FIRE SAFETY INSPECTION REPORT

Al-Muslim Apparels Ltd.

Factory ID: 24035

Fire Safety Inspection Report

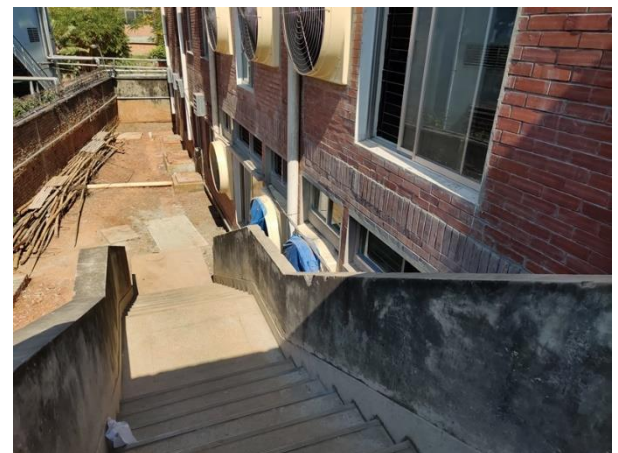
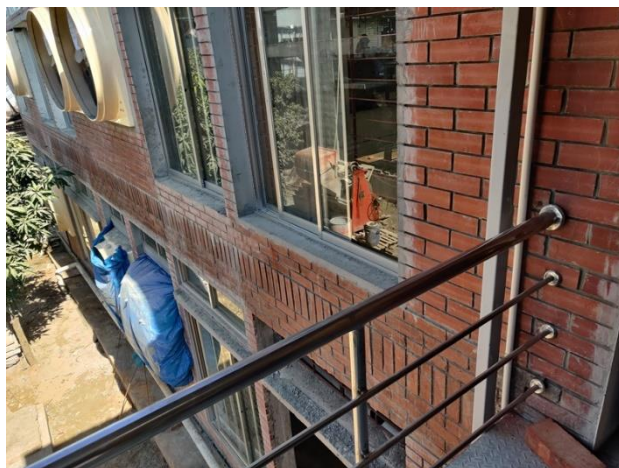
F-3	Fire Rated Construction	Areas on the 1 st and ground floor used for combustible storage open to the factory are not properly defined and/or not within limits.	Provide defined storage areas and limit the storage arrangement as follows: Maximum height of 2.45m (8 ft) and maximum area of 23 m² (250 ft²). If sprinkler protected: maximum height of 3.66m (12 ft) and maximum area of 93m² (1000 ft²). Separate the areas of unenclosed combustible storage by a minimum clear distance of 3 m (10 ft).	Within 3 months
-----	-------------------------	---	---	-----------------
